PRODUCT ADVISORY

Data Sheet Specification Change for Intersil Products ISL78600ANZ and ISL78600ANZ-T

**Refer to:
PA13004**

Subject: **Data Sheet Specification Change for Intersil Products ISL78600ANZ and ISL78600ANZ-T**

- Figure 44 – Typical Application Circuit

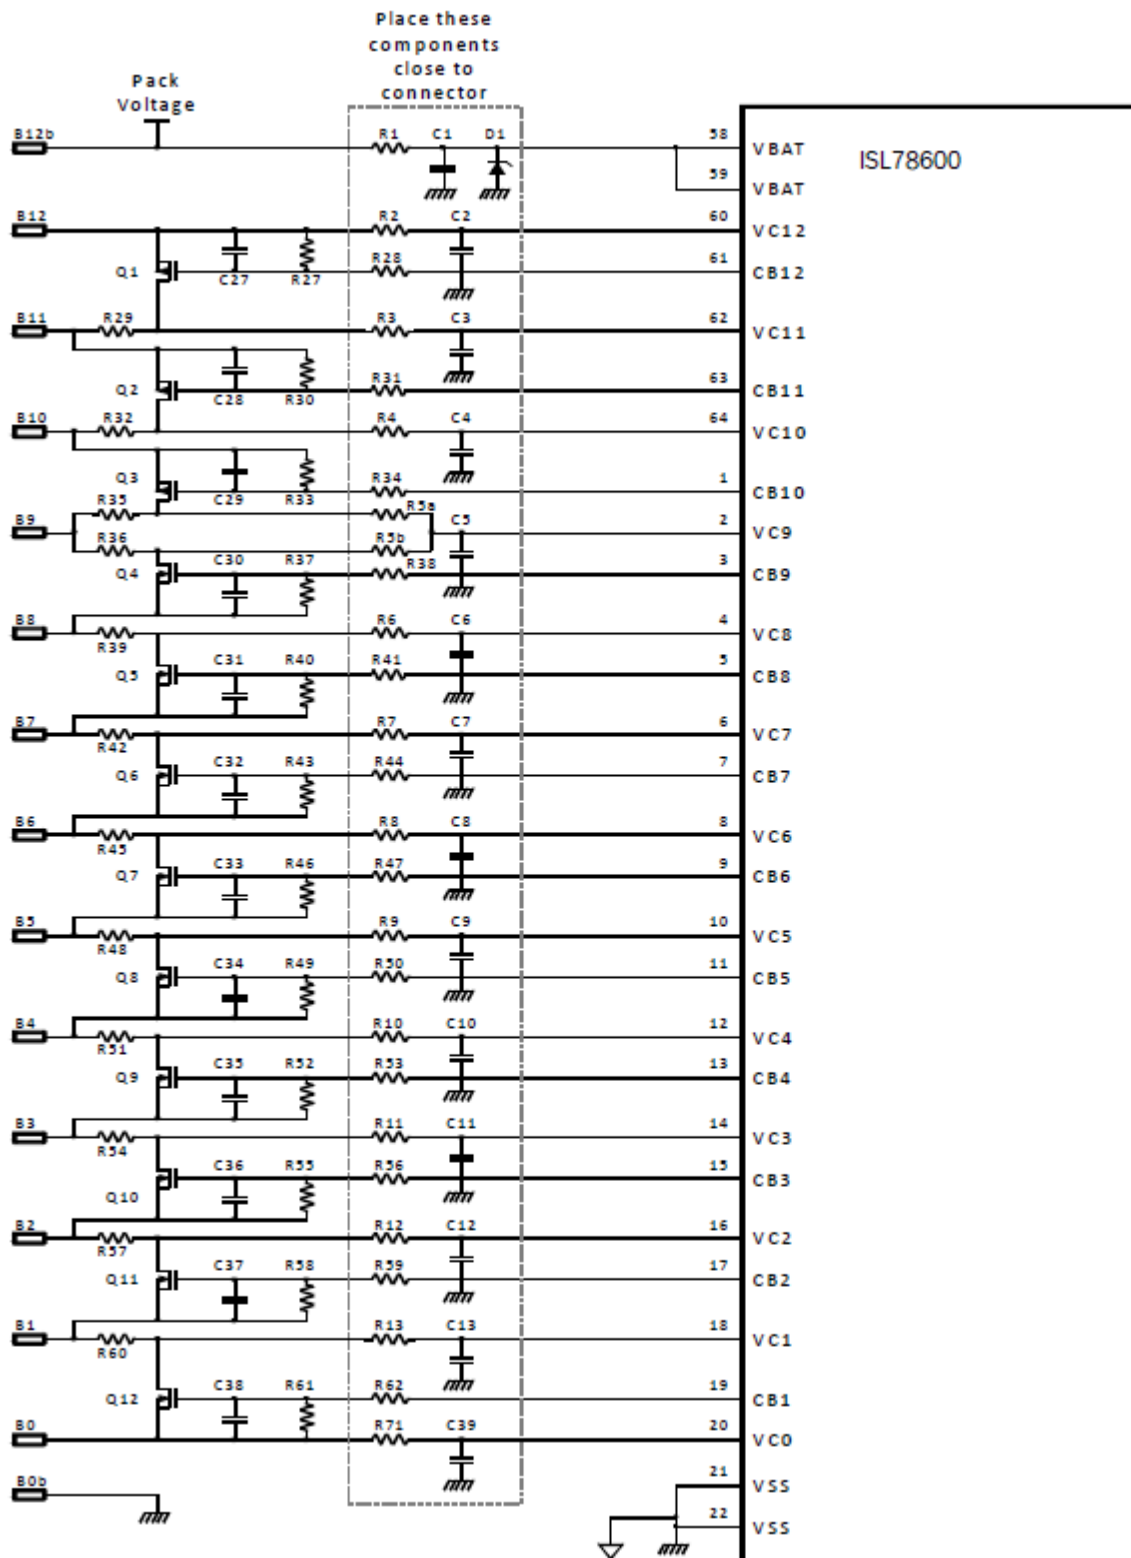
This advisory is to inform you that Intersil has updated the data sheet specification for the ISL78600ANZ and ISL78600ANZ-T products. The updates affect the *Typical Applications Circuits (Figures 45–47)* along with the associated recommended component values in *Table 50* and the component values in *Table 52* for the Daisy Chain Circuit. The resulting Typical Applications Circuits and component tables are included on the following pages. The updated data sheet is available upon request.
